Service Note

10-016 15 July 2010

CPU REPLACEMENT INFO ON E-SERIES ANALYZERS

Figure 1

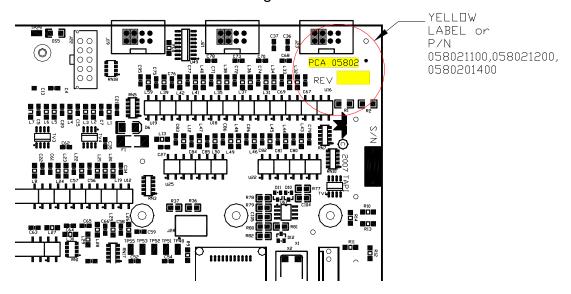
First, you must identify what type of motherboard your instrument currently has. This can be done by locating the part number or label in the upper right hand corner of the motherboard. (See Figure 1)

This part number must read 058021100, 058021200 or 058021400. If the part number is not correct the label **MUST** be **YELLOW** in color, the yellow label indicates that the motherboard has been reworked to the latest version to accommodate the new CPU. If both the part number and label are incorrect you must choose the kit that contains the new or reworked GEN 5 motherboard in TABLE A. Otherwise use TABLE B. (See the tables on the next page of this service note)
